April 12, 2018
Staff Report to the Southeast
Town Design Review Committee

CASE #MPL2018-10010
Item #1

TYSONS CORNER II COMMERCIAL SPMP

TYSON'S CORNER II PD, TRACT "A" COMMERCIAL
SPECIFIC PARCEL MASTER PLAN AND PRELIMINARY SUBDIVISION PLAN
CITY OF ORLANDO, ORANGE COUNTY, FL

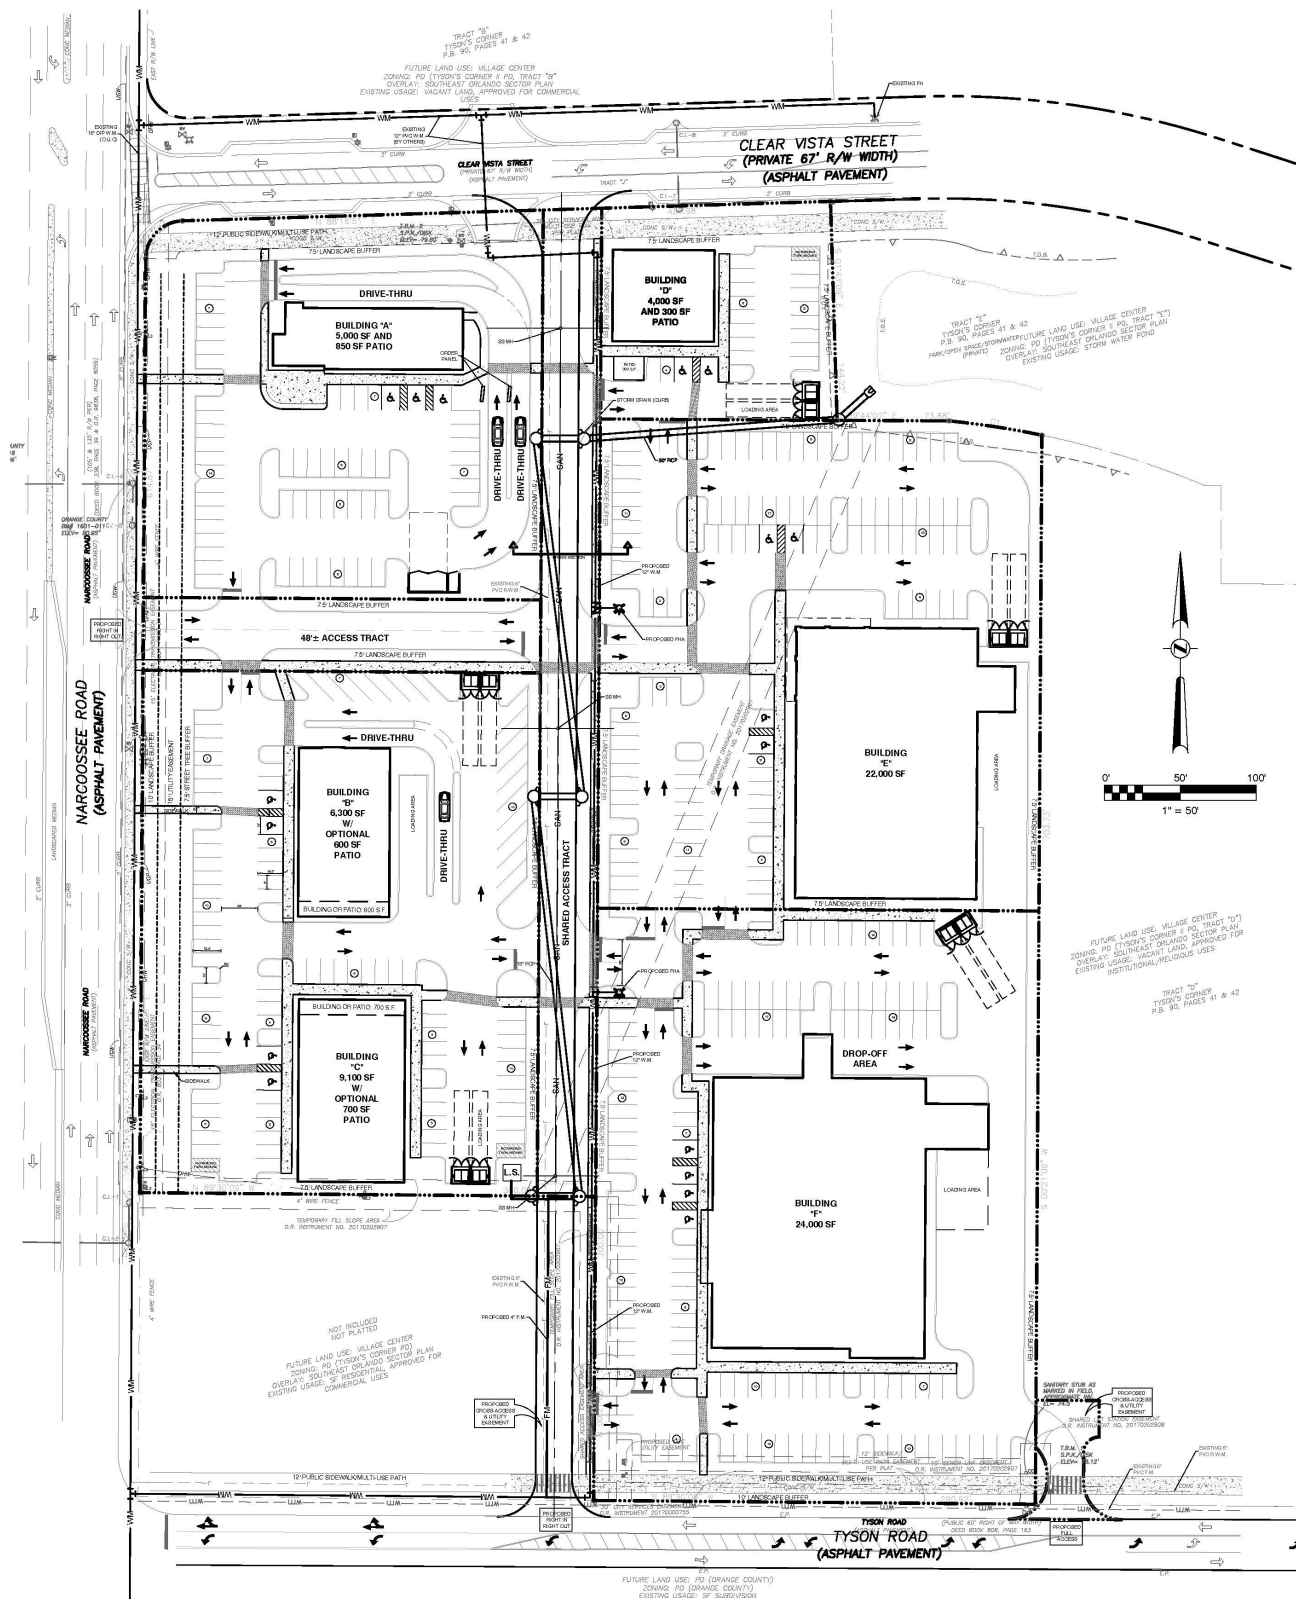
- a. The building setbacks shall adhere to the table below. An alternative standard is requested for the rear (east) setback for Building E, a 16.6' setback is requested where a 20' minimum is required. This alternative standard is approved.
- b. Setbacks may be amended by 5' through the appearance review determination in order to accommodate architectural and site design requirements. However, the setbacks may not go below the minimum requirements or the alternative rear setback for Lot E.

The rear facades of Building E and Building F must not appear to be back of house. The rear facades must contain the same level of architectural detail in appearance and complexity as the front façade and sides.

SHARED ACCESS TRACT CROSS SECTION

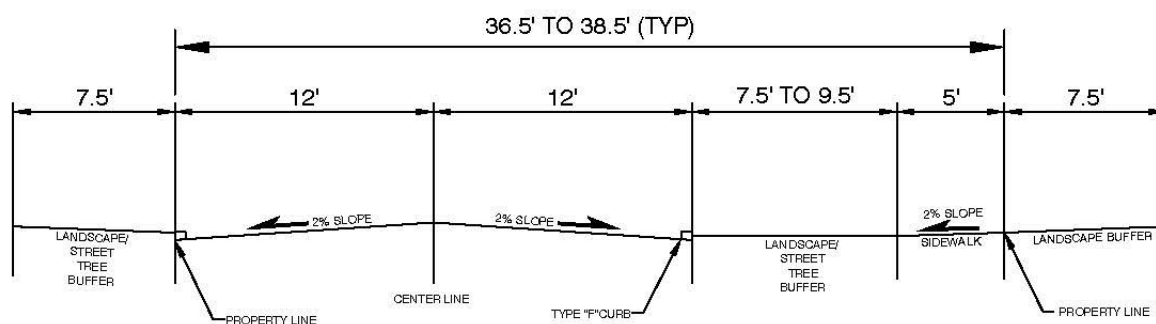
The proposed landscaping plan shows a 7.5 ft. minimum landscaping depth around the perimeter of the site. The site must also adhere to the required setback and landscaping requirement for Narcoossee Road and Tyson Road from the Tysons Corner II PD. Narcoossee Road setback is 32.5', which includes 15' utility easement, 7.5' street tree area and a 10' wide landscape buffer. Tyson Road setback is 21', which includes the area required for an additional travel lane on Tyson Road, a bike lane, a sidewalk, all of which have been constructed, and a 10' landscape buffer.

VEHICULAR AND PEDESTRIAN CIRCULATION PLAN

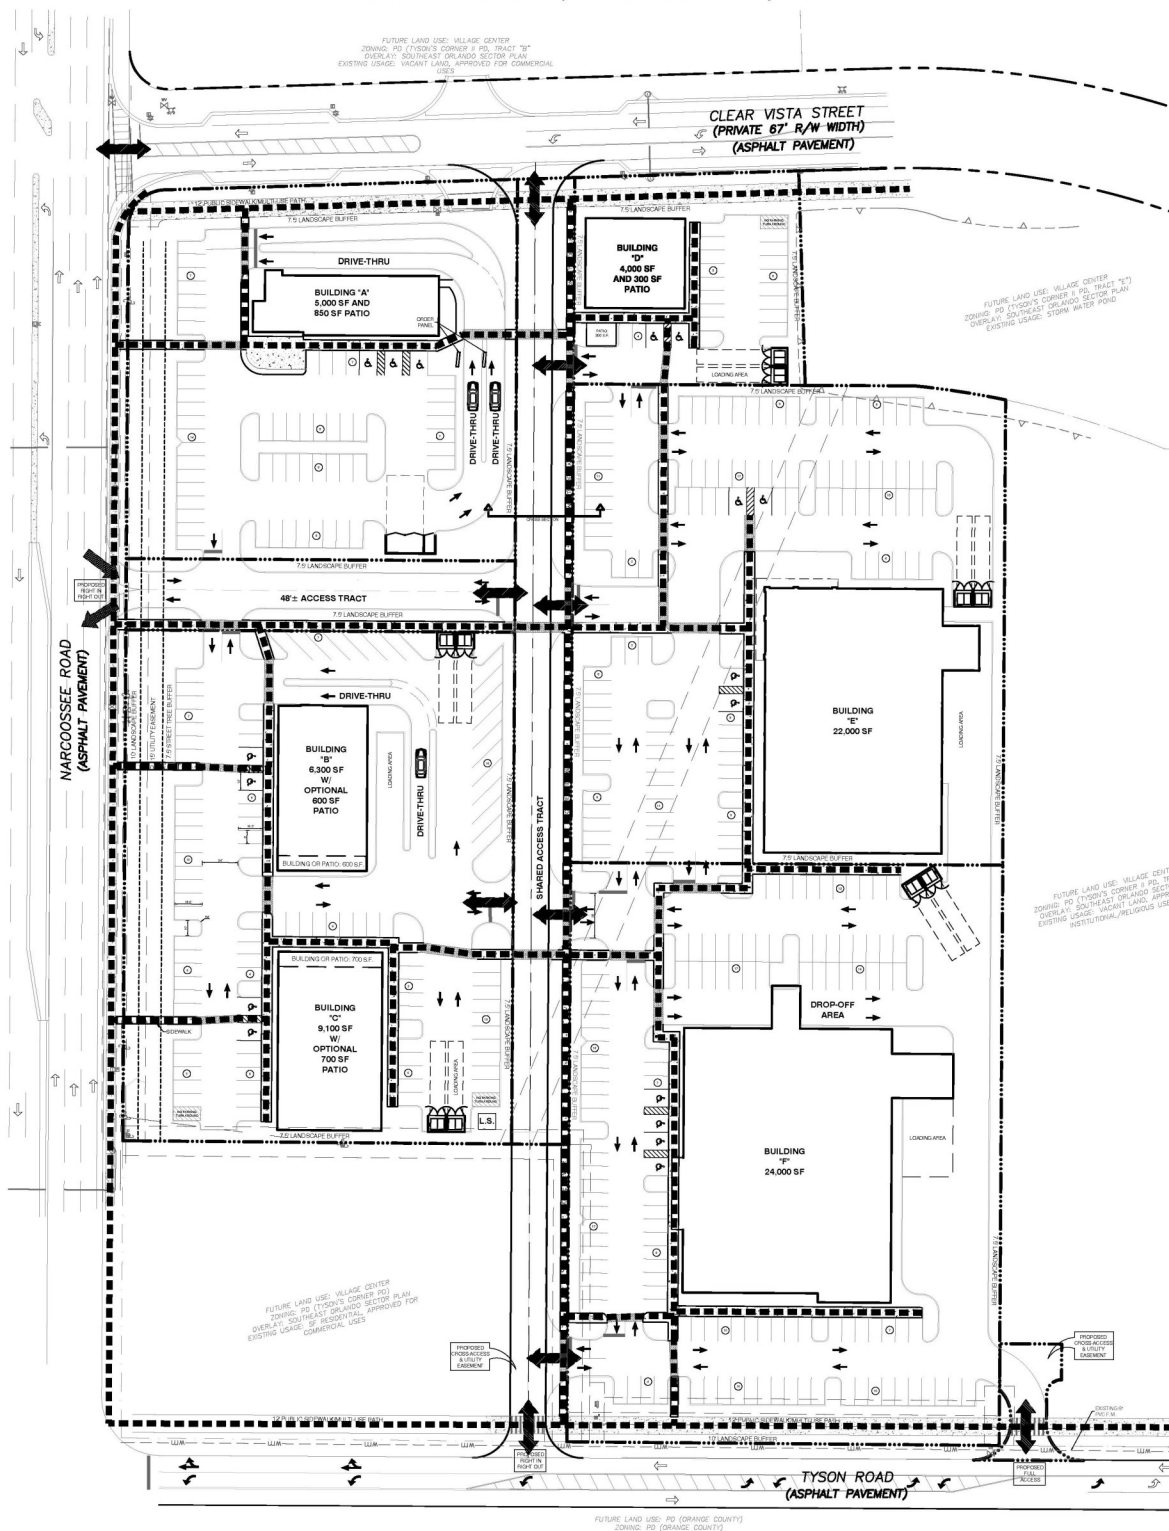
- a. To create a sense of community, and promote logical street and sidewalk network to surrounding uses, the following standards shall apply:
 - i. Create a pedestrian network throughout the site, and connect to the public sidewalks along the ROW. Sec 61.314.

- ii. Internal cross walk connections must be established to all buildings on the site.
 - iii. Pedestrian walkways shall be designed to provide direct connections between all building entrances, adjacent rights-of-way, transit stops, and outparcels.

- b. All crosswalks must be constructed with textured colored concrete or similar at all internal drives and intersections where a pedestrian connection occurs. Crosswalks at both main entrances shall also be decoratively treated so that the pedestrian path is visually dominant compared to the vehicular entrance. The path shall be constructed with a contrasting material, such as pavers or textures colored concrete or similar.

Applicant shall request permission from the property owner to the north to eliminate the barrier at the northern terminus of Sunstone Ave. If permission is granted, the applicant shall construct the missing segment, including a speed table to provide traffic calming, after 70% of the commercial buildings are built.

The applicant must coordination with Orange County on the location of the driveways into buildings A & B just east of Narcoossee Road. Orange County has been requiring 70 ft of stacking space between the ROW line and the center-line of the first driveway. The applicant must verify with Orange County to verify that these driveway entrances are far enough east to meet Orange County criteria for these entrances.

Proposed Landscape Plan

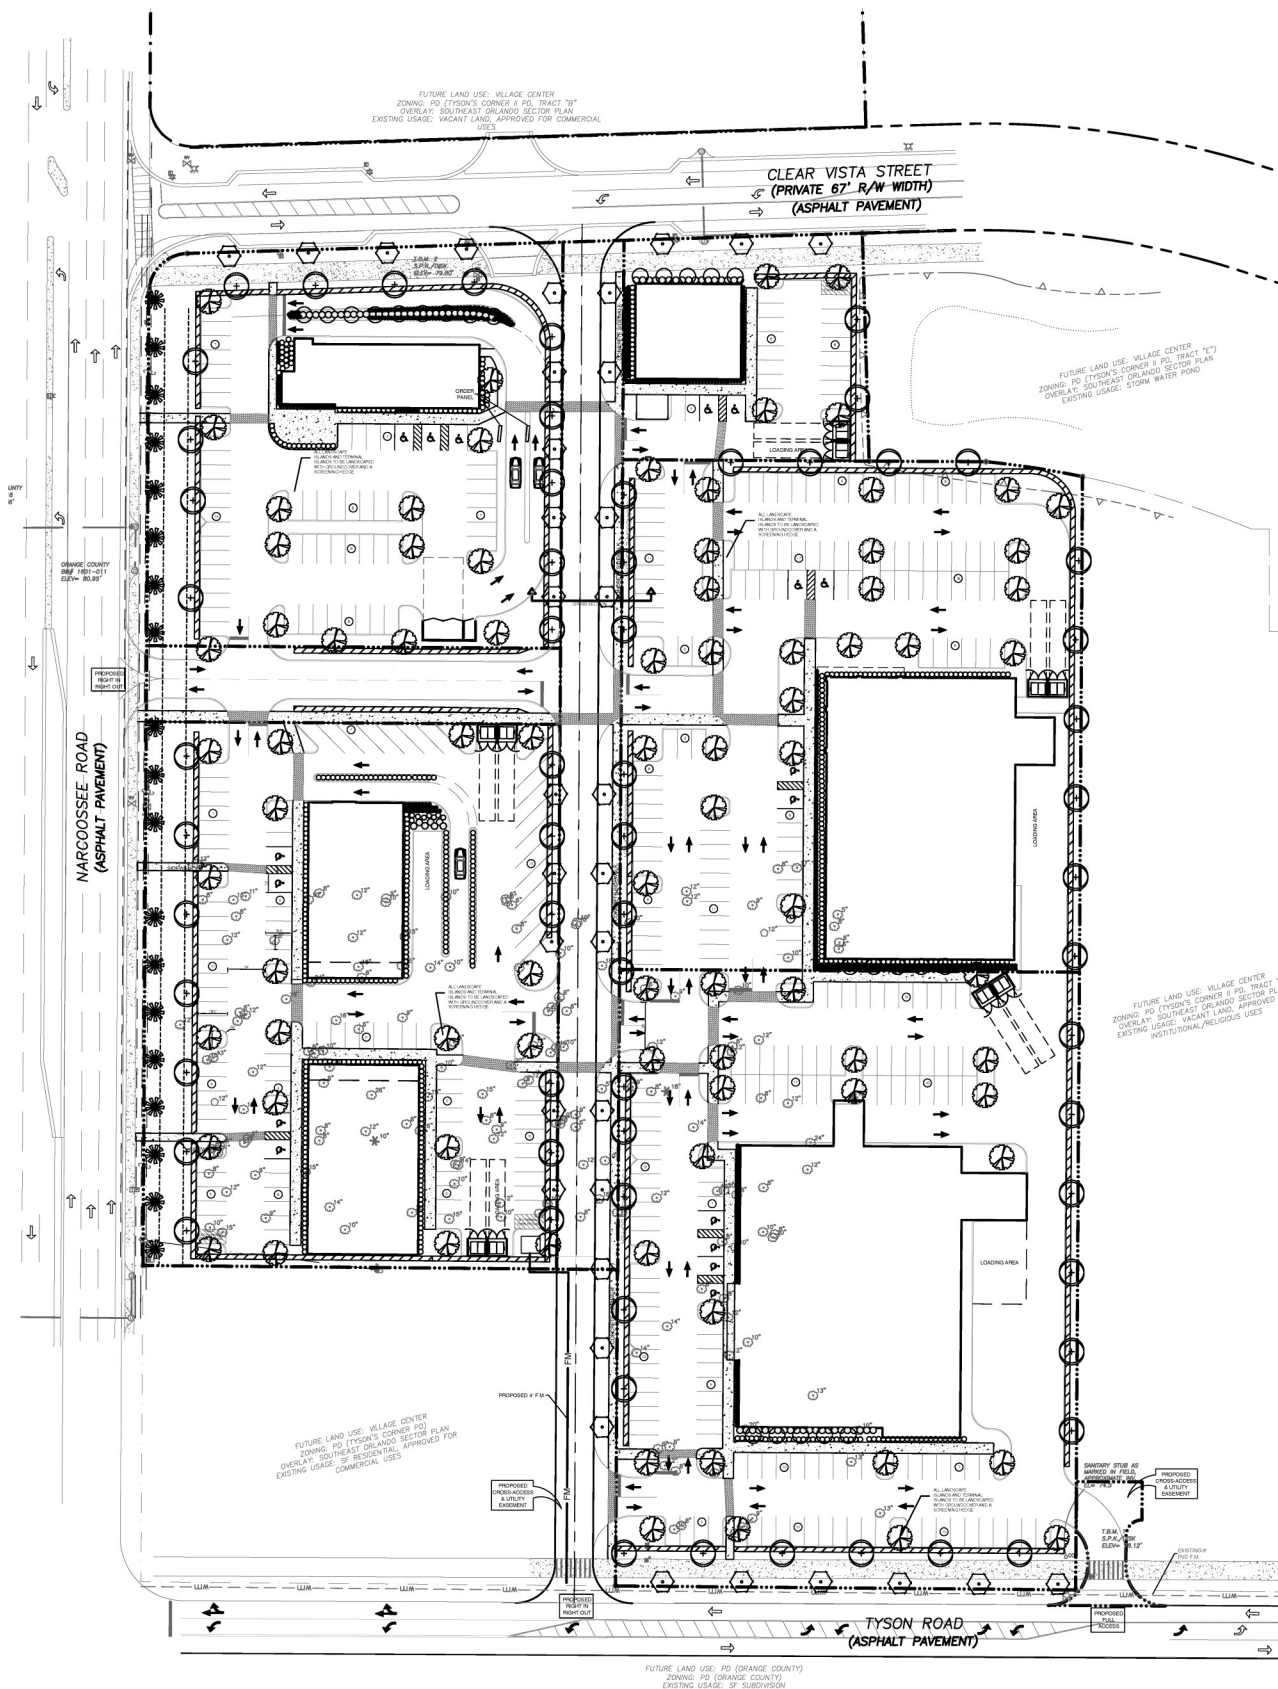
- a. All surface parking areas shall meet the minimum landscape requirements of Chapter 60 of the LDC.
- b. Street trees are required within established rights-of-way along public and private streets (Sec. 60.216)

- c. Canopy trees shall be planted in the parkways on both sides of the street, in accordance with Chapter 61.
- d. The minimum width of landscape parking lot islands are 10ft.

- e. Every row end parking must have a landscape island. Each row end parking must have a tree.
- f. The maximum number of parking spaces allowed between landscape area is 10 parking spaces or refer to Section 61.312.

- g. All landscape plans must achieve the Minimum Required Landscape Score (MRLS) required for the proposed type and intensity of development. Meet City Code Chapters 60 and 61. A spreadsheet showing compliance with the Minimum Required Landscape Score must be included with the plans. A digital spreadsheet form is available at <http://www.cityoforlando.net/city-planning/landscape-code/>.
